SECTION 73
SUPPLEMENTARY DESIGN REPORT

SEPTEMBER 2021

This report is intended to illustrate the differences between the consented development scheme and the latest proposed design iteration. The proposed design incorporates changes concerning the refinement and evolution of the consented design in response to concerns of environmental, practical, and cultural changes that have occurred through the course of the project.

Proposed Scheme Phasing

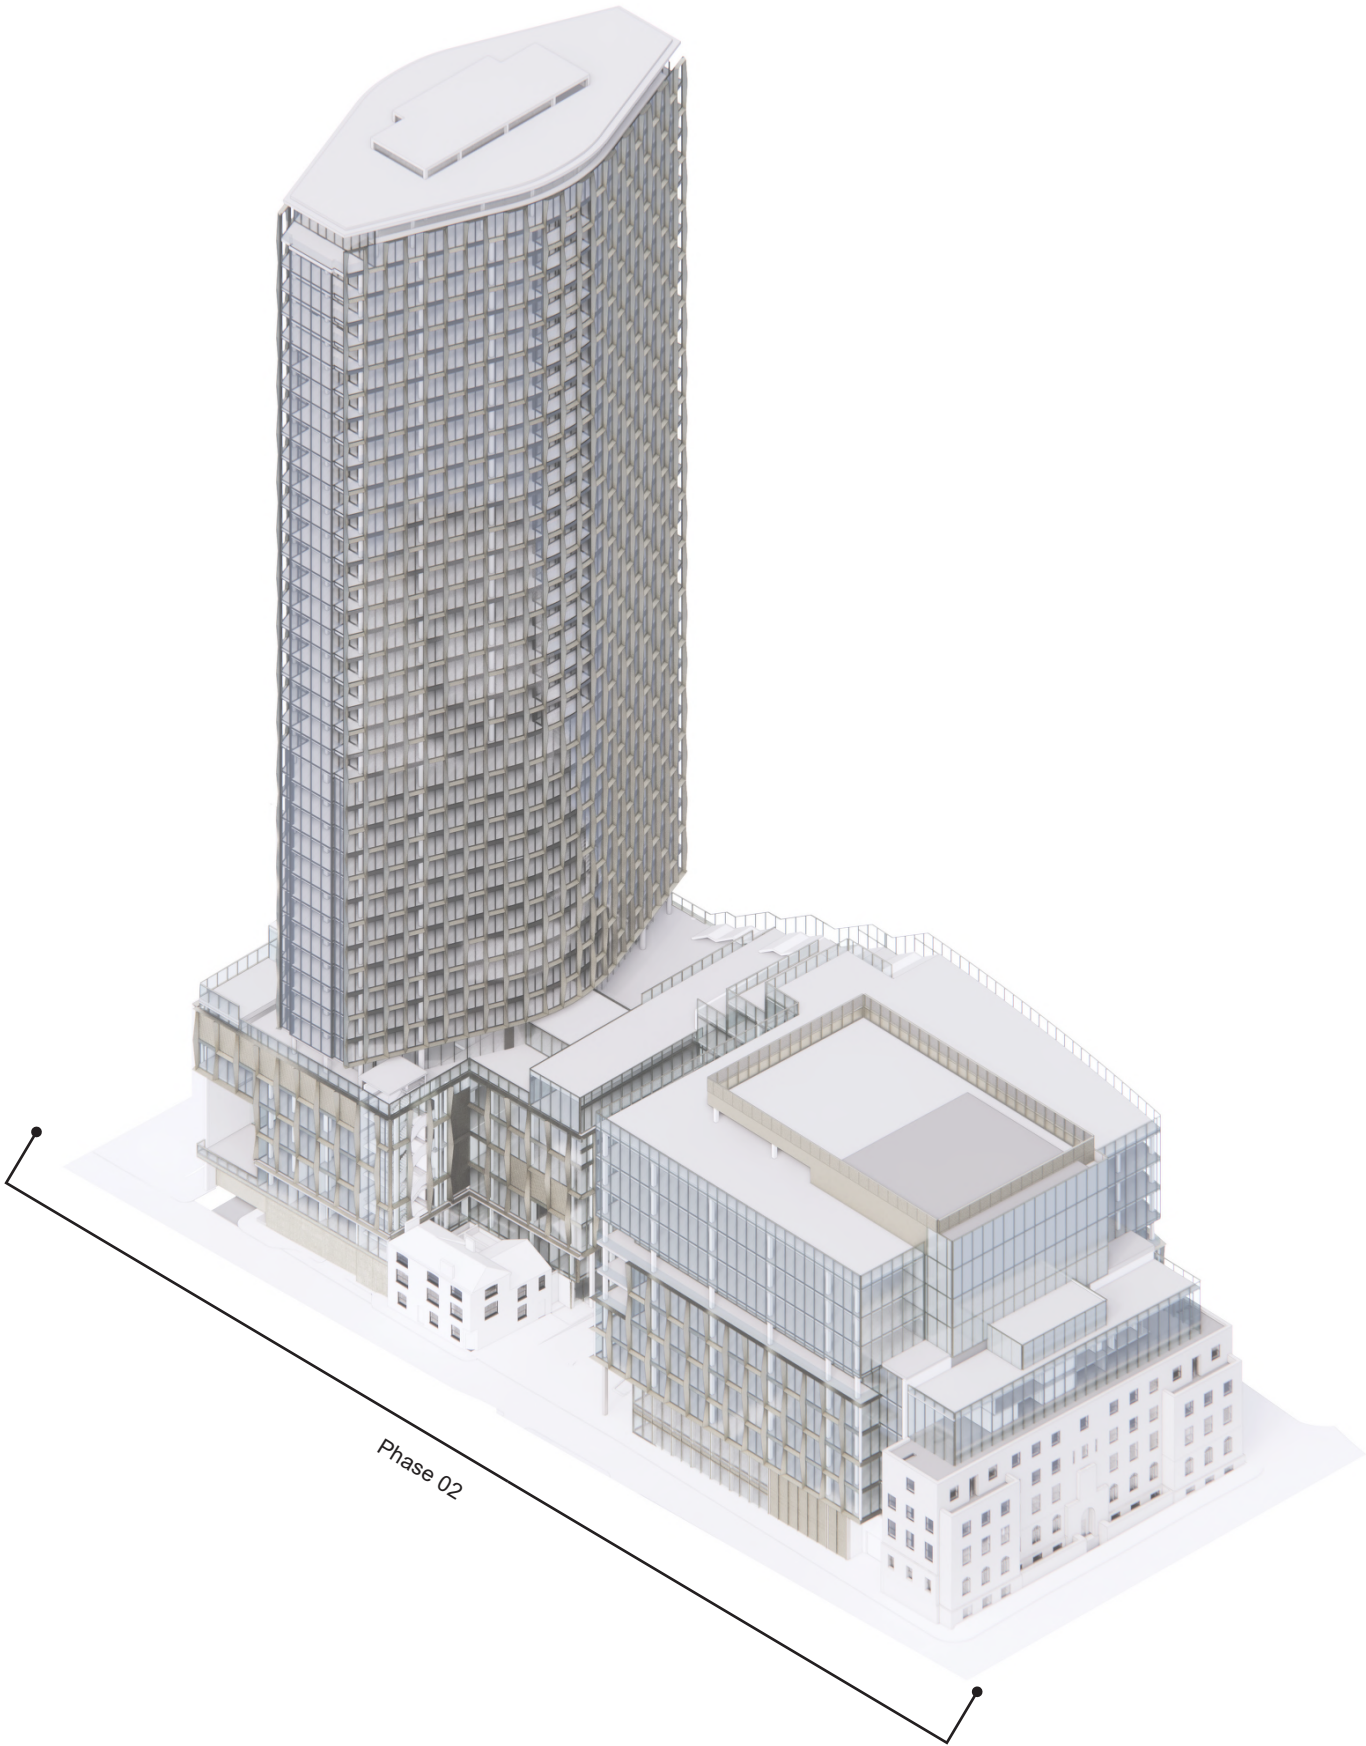
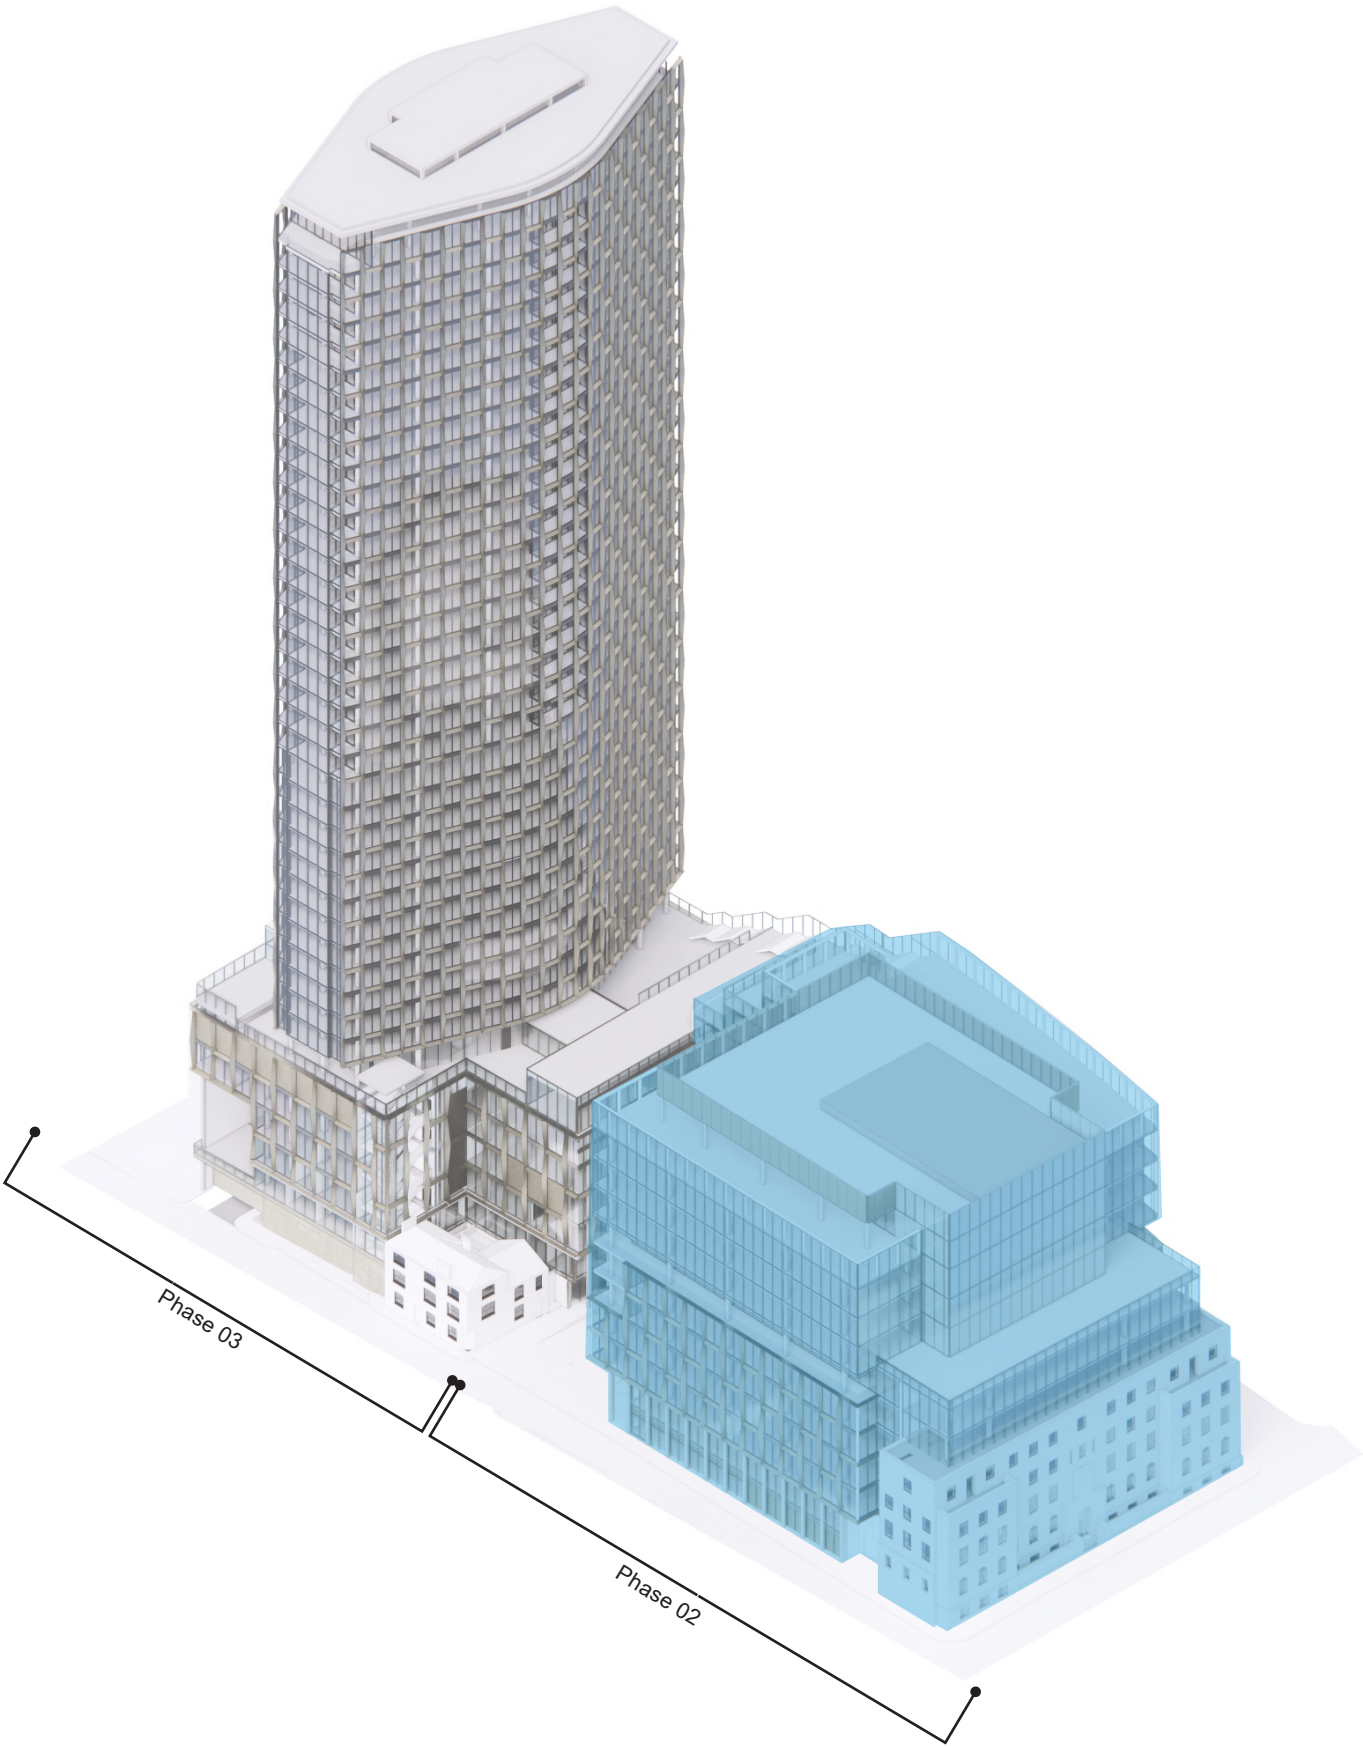
- Phase 1 – Demolition of the Sir Ralph Abercromby pub kitchen
- Phase 2 – Construction of office building and works to former police station
- Phase 3 – Construction of synagogue, hotel and residential tower
- Phase 4 – Refurbishment of Pub

In summary, whilst it was previously envisaged that the former police station external works will take place in Phase 2, with the fit out forming a separate element of work in Phase 4, the works to the former police station will now all take place within Phase 2.

It is also now intended that Phases 2 and 3 will be capable of being delivered and operated interdependently.

Proposed Basement Level -2

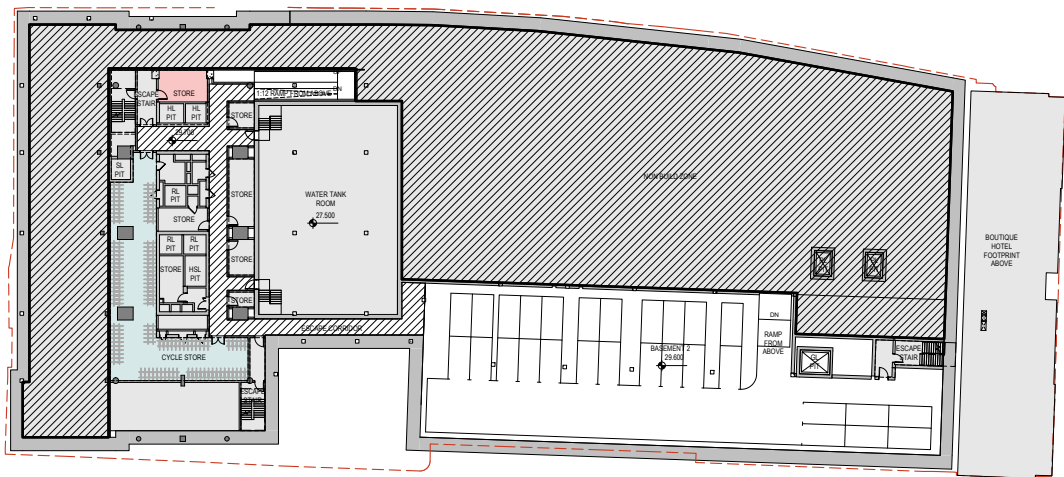
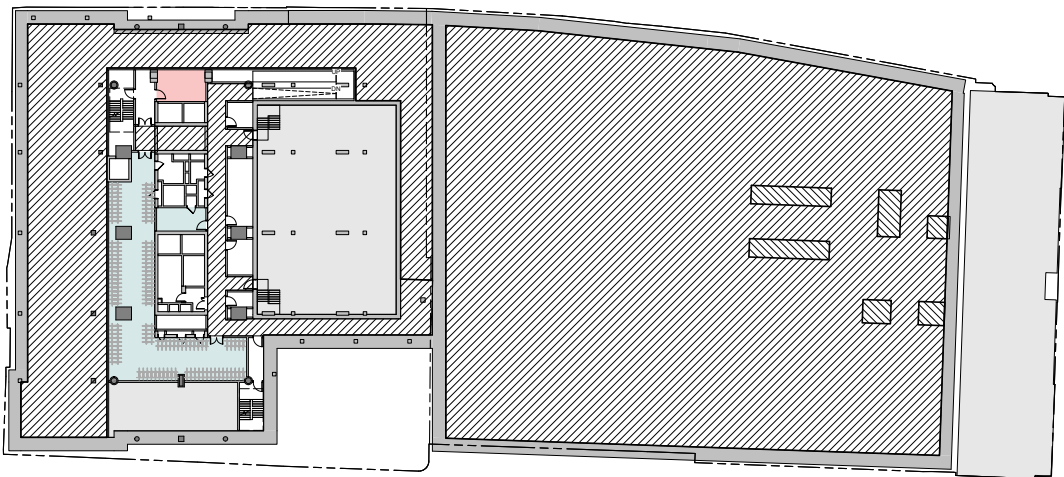
The Lower Basement under the office block has been removed to reduce risk and complications due to existing foundations. The basement above is rendered more efficient due to the removable of access ramps. This lowers the number of available car parking spaces in the project.

Proposed Basement Level -1

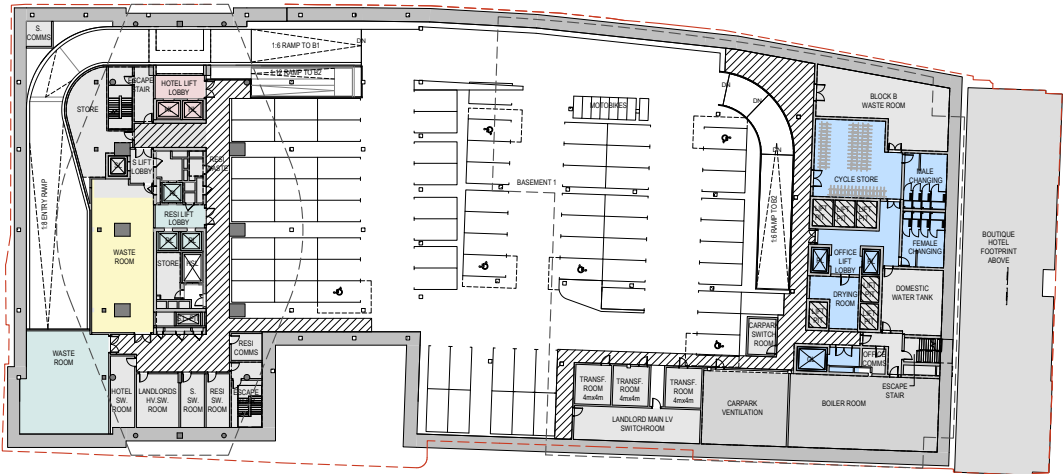
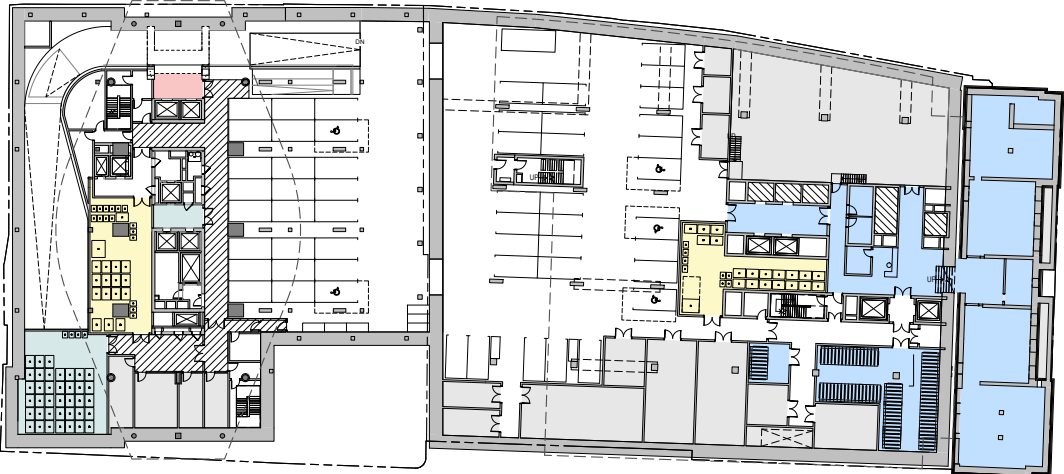
The main basement has been reconfigured so that both phases of the project can operate independently. This allows flexibility in how the buildings are constructed and operated in the long term. In response to evolving preferences for transportation, fewer car park spaces have been provided, while bicycle parking has been increased for office tenants. To support the increase in alternative modes of transportation, expansive changing and showering facilities have been added in the basement of the former Police Headquarters.

Car Parking Spaces	54
	(Inc. 5 Accessible)
Cycle Spaces	400

Proposed Ground Floor Plan

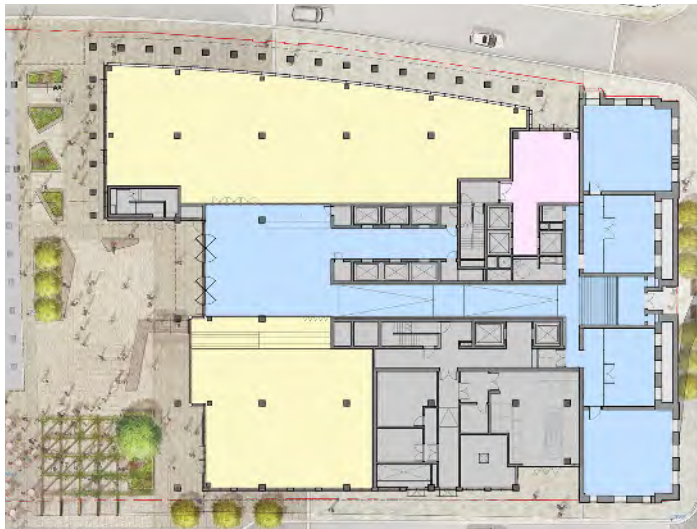
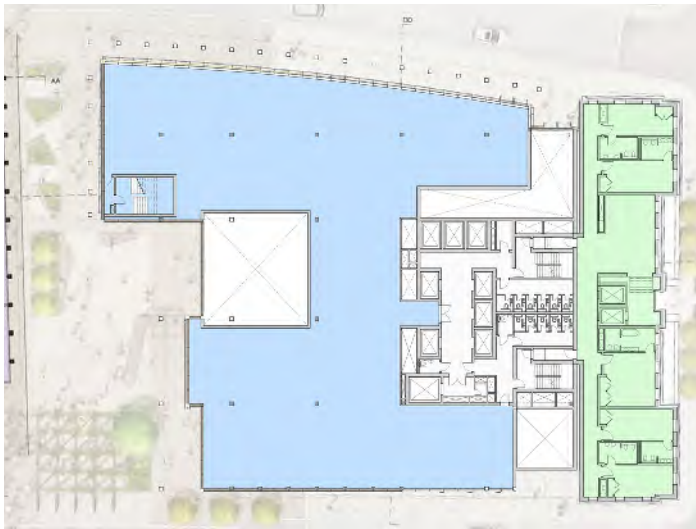
The former Police Headquarters has changed proposed use from a Boutique Hotel to an Office, which is to be integrated into the larger Office program. An entrance lobby in the former Police Headquarters connects through to the primary Office Lobby, creating an interior connection between Southmill Street and the public square. The revised core organisation supports this connection. The Back-of-House zone of the Office Block facing on to Bootle Street has been expanded to ensure that it can operate independently from the Hotel and Residential building if required. This includes a reconfigured loading bay facing onto Bootle Street to better support building operations.

Proposed Level 01

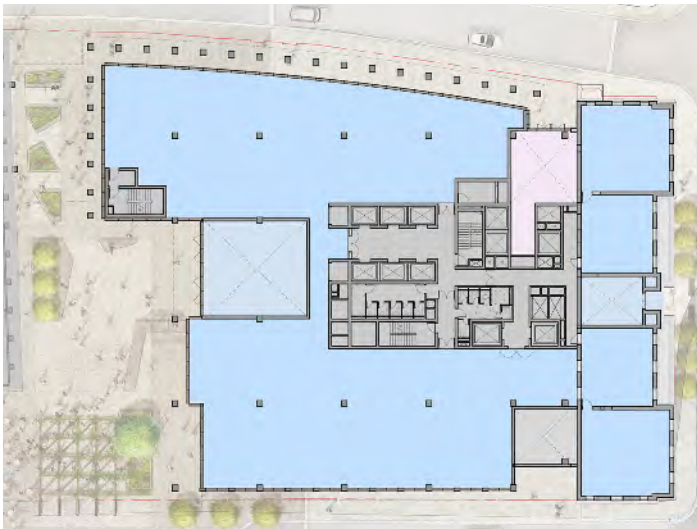
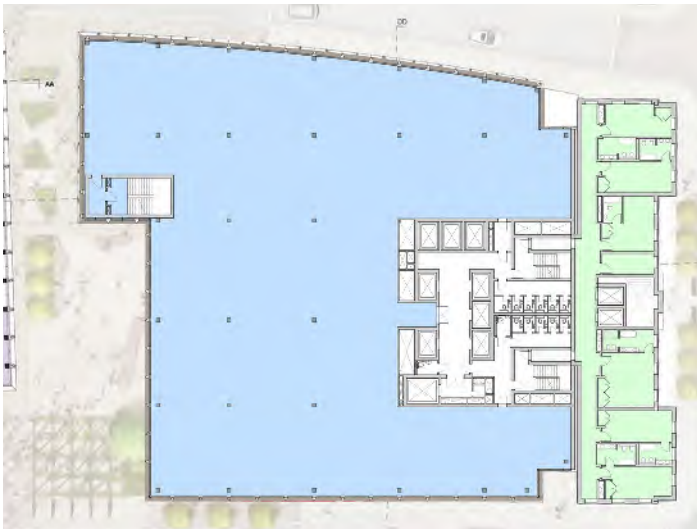
The revised office core creates a more equivalent depth between the facade and the core around the building, allowing access to daylight for more of the office users. At Level 01, this change allows the office floorplate to connect into the former Police Headquarters and supports the integration of the buildings.

Proposed Level 02 Plan

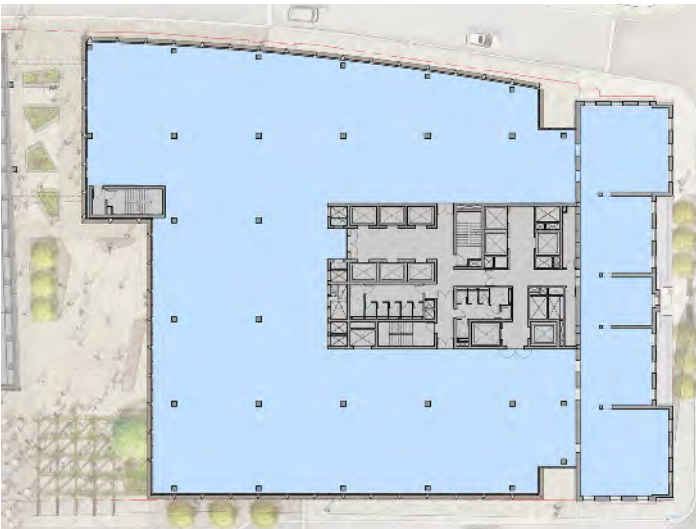
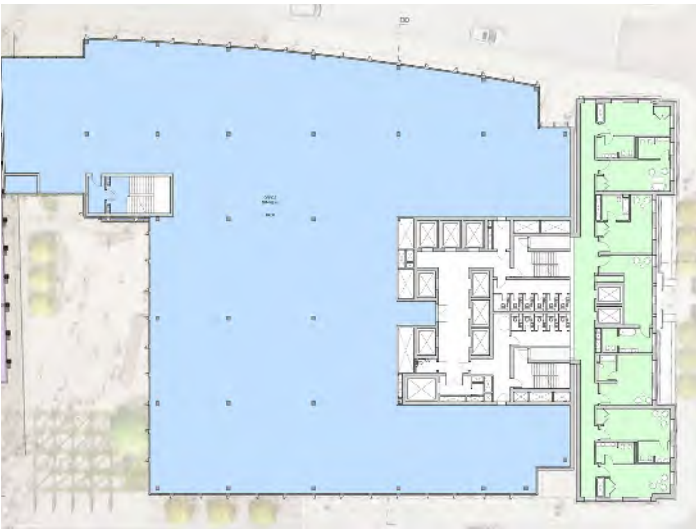
At Level 02, the new office and the existing building are fully integrated, with the back wall of the former Police Headquarters adding a sense of history and character to the office.

The equalised depth of the office space around the core is more apparent at this level, showing that in addition to better daylighting conditions, the space is also more flexible for different types of occupants.

Proposed Level 03 Plan

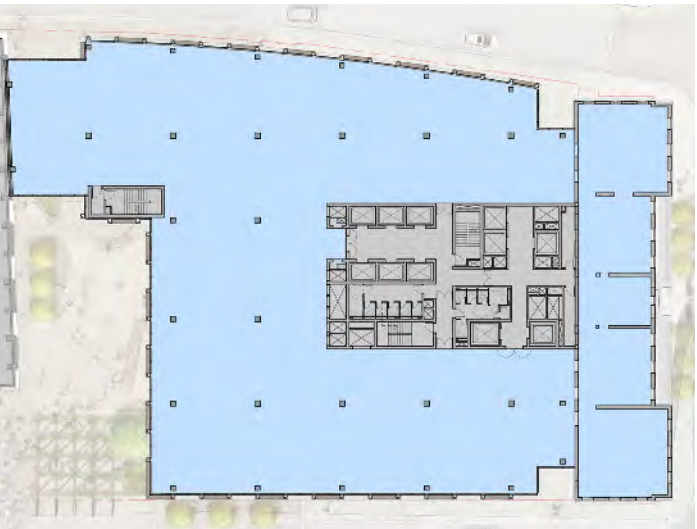
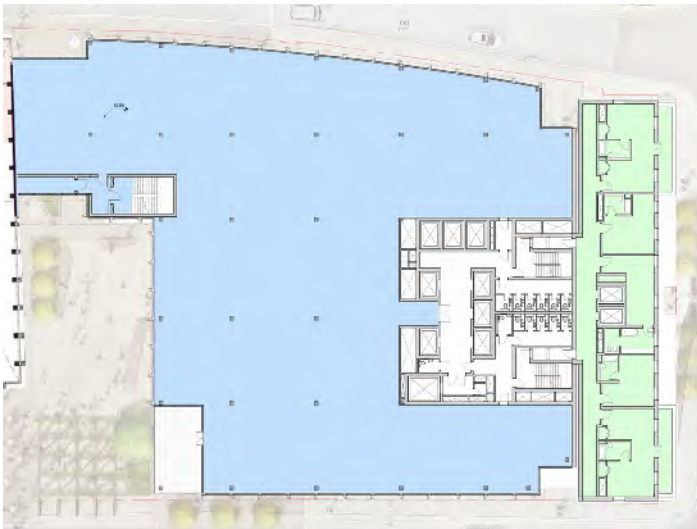
The office floorplate is similar to the proposed Level 02 plan, with an additional “bridge” area expanded to meet Block A. This “bridge” area is also present in the levels directly above in both the consented and proposed scheme.

Proposed Level 04 Plan

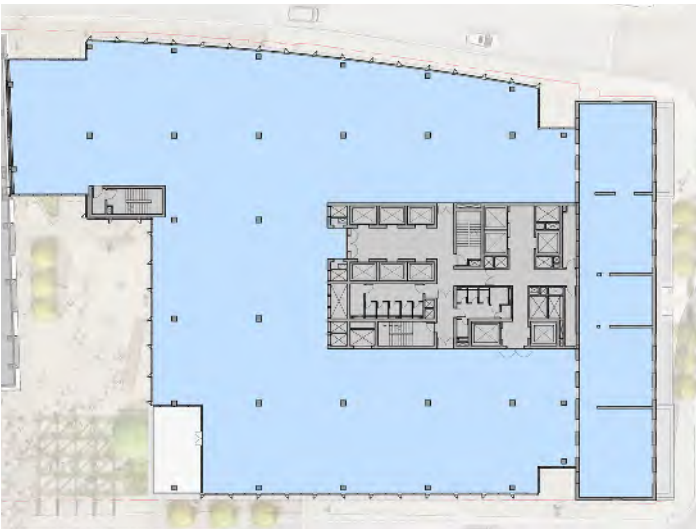
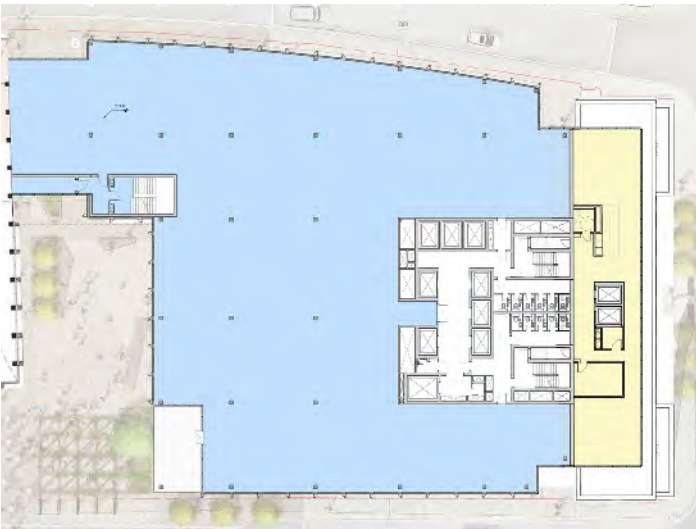
The main body of the office area on Level 04 is similar to the proposed Level 03, with the inclusion of a terrace in the southwest corner. The dimensions of the terrace align with the facade module and structural constraints.
